February 24, 2016

Re: Site Plan II Application Response to Comments  
Proposed Taco Bell, 1363 Washington Ave, Portland, ME

On behalf of the applicant, Guggenheim Retail Real Estate Partners, Inc., VHB has prepared the following responses to the review comments received from the Department of Public Works and Planning Department, dated February 11, 2016 and the Stormwater Peer Review, dated February 15, 2016 for the conversion of the existing Sala Thai restaurant to a Taco Bell facility. Please find the following materials included to accompany the responses:

TACO BELL  
 1363 WASHINGTON  
 PORTLAND, ME  
 PREPARED BY: JOHN BUJAKE  
 ACCUSERV LIGHTING & EQUIPMENT  
 877-707-7378  
 502-961-0357 FAX  
 jbujaake@accu-serv.com  
 FEBRUARY 22, 2016

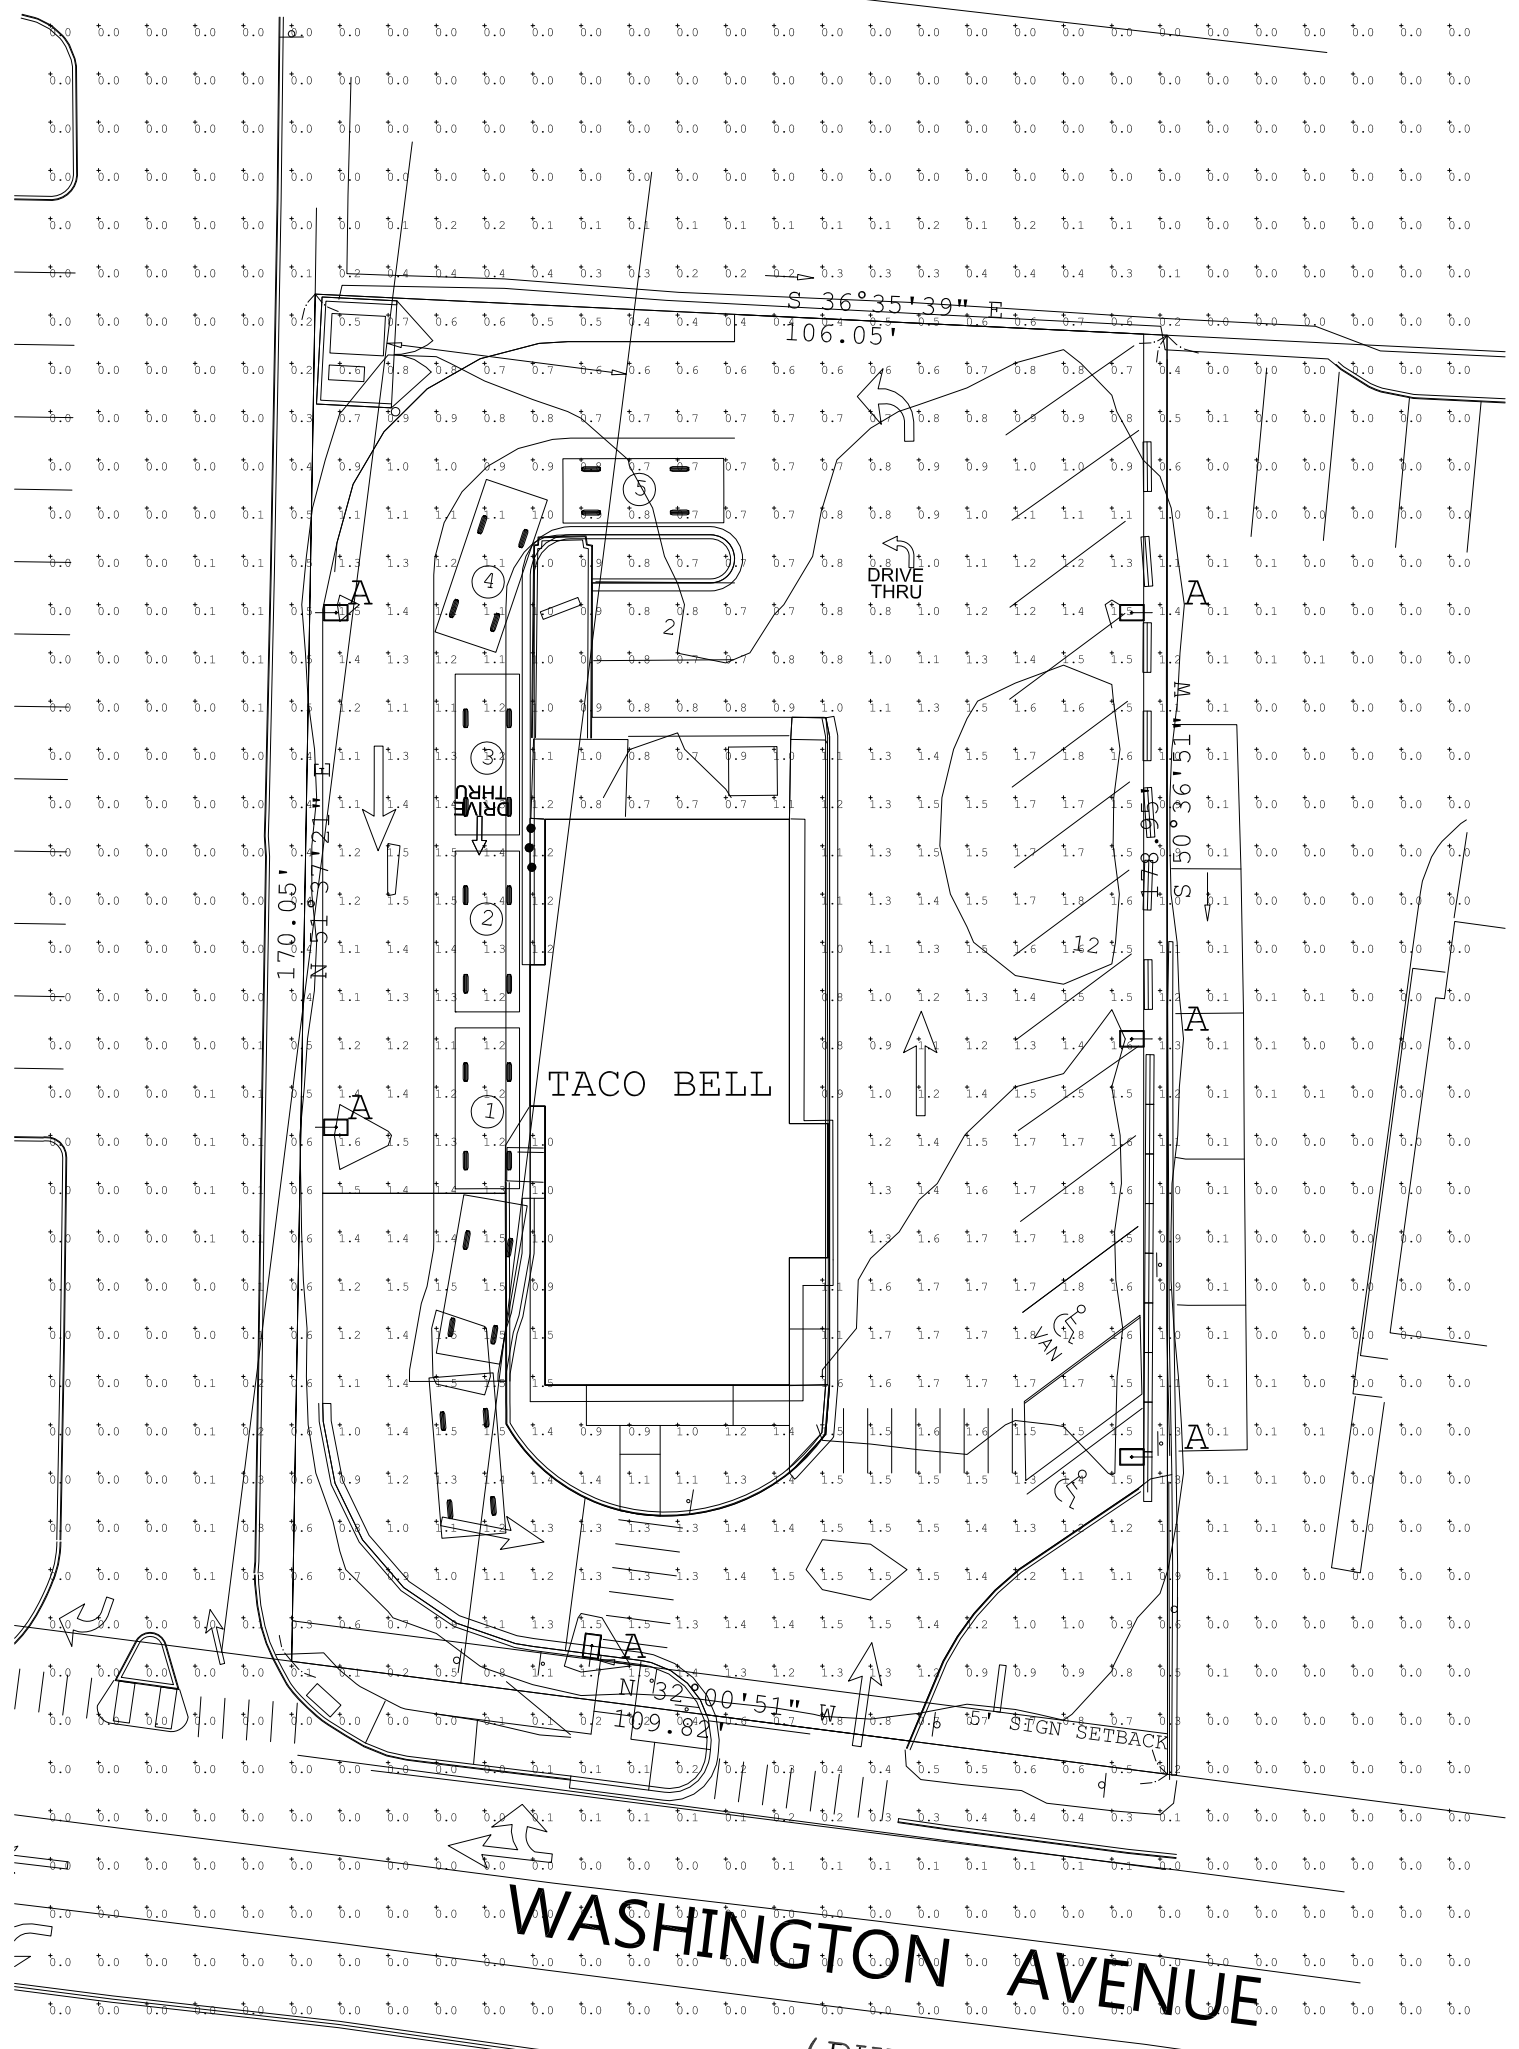
3. Lighting: *The proposals for lighting should identify both the wall-mounted and free standing light fixtures and both should be shown on the photometric plan. The light levels should meet the standards set out in the Technical Standards and I attach the relevant section. (the submitted photometric plan shows levels above the standard).*

The photometrics plan has been revised to adhere to the lighting standards. The fixtures were changed to reduce lighting off-site and pole heights were reduced from 25-feet to 17.5-feet. The revised plan is attached.
